## UNITED STATES PATENT AND TRADEMARK OFFICE

APPLICATION NO.	FILING DATE	FIRST NAMED INVENTOR	ATTORNEY DOCKET NO.	CONFIRMATION NO.
10/755,583	01/12/2004	Jeffrey Kozak	4002-3420	9189
30565	7590	03/17/2005		
WOODARD, EMHARDT, MORIARTY, MCNETT & HENRY LLP BANK ONE CENTER/TOWER 111 MONUMENT CIRCLE, SUITE 3700 INDIANAPOLIS, IN 46204-5137			EXAMINER RAMANA, ANURADHA	
			ART UNIT 3732	PAPER NUMBER

<b>Office Action Summary</b>	Application No. 10/755,583	Applicant(s) KOZAK ET AL.	
	Examiner Anu Ramana	Art Unit 3732

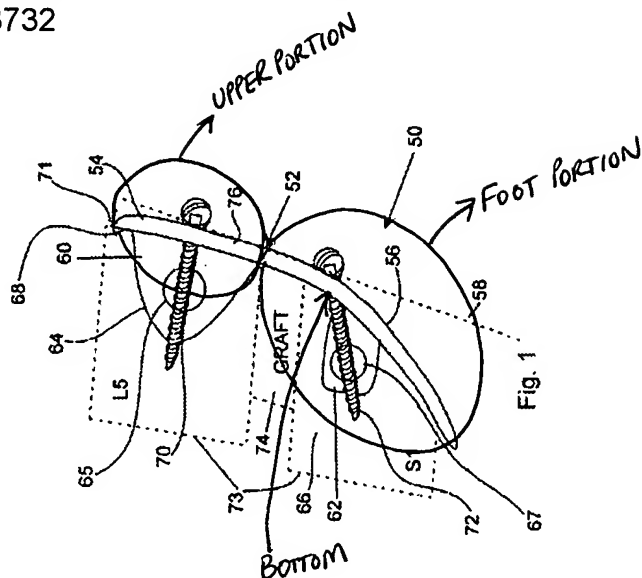
Claim 13 is rejected under 35 U.S.C. 102(e) as being anticipated by Zucherman et al. (US 6,045,552).

Zucherman et al. disclose a plate for use in immobilizing L5, S1 vertebrae having: a foot portion partially in the intervertebral space; screws 65 in the upper portion of the plate, fixing the plate to an L5 vertebra; and screws 72 extending downwardly from the front through the bottom of the foot portion into S1 (Fig. 1, col. 3, lines 22-67 and col. 4, lines 1-16). See marked up Figure 1 on following page.
